RE: Responses to the Environmental Report Request for Additional Information for the Nichols Ranch
ISR Project License Application (TAC J00553, Docket No 040-09067)

**Request for Additional Information
Regarding the Uranerz Energy Corporation's
Nichols Ranch ISR Project License Application
Environmental Report – Uranerz Energy Corporation Responses**

FIGURE 3-23

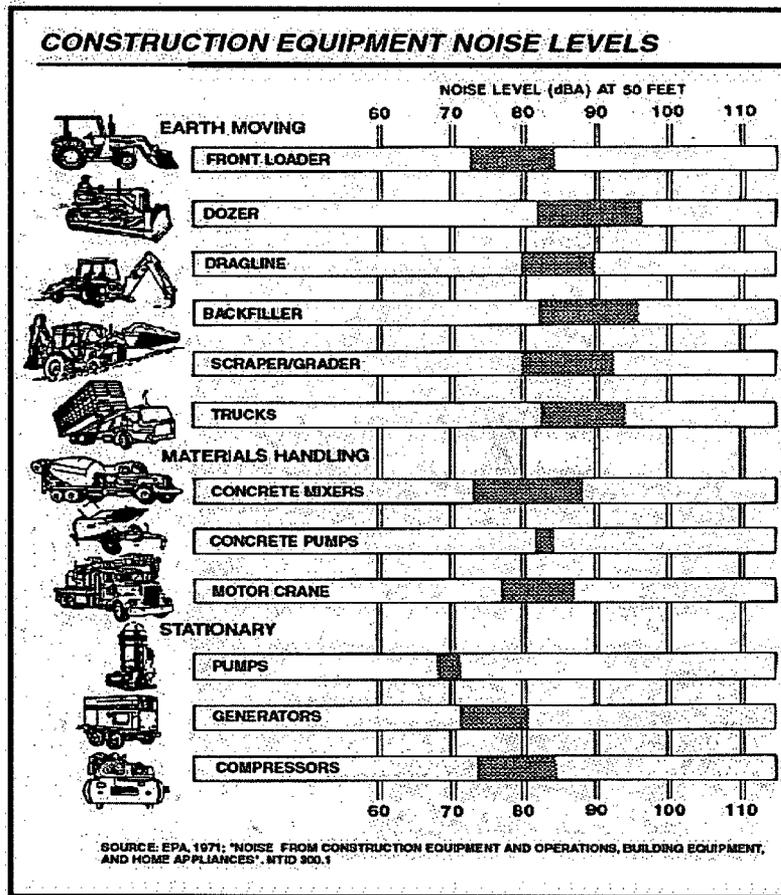
- a) Provide projections of typical equipment and their reference sound levels that would be associated with activities during each phase of the proposed project.

Typical equipment that will be used for the Nichols Ranch ISR Project and their noise levels are below. Section 4.9.1 has been revised to include this information.
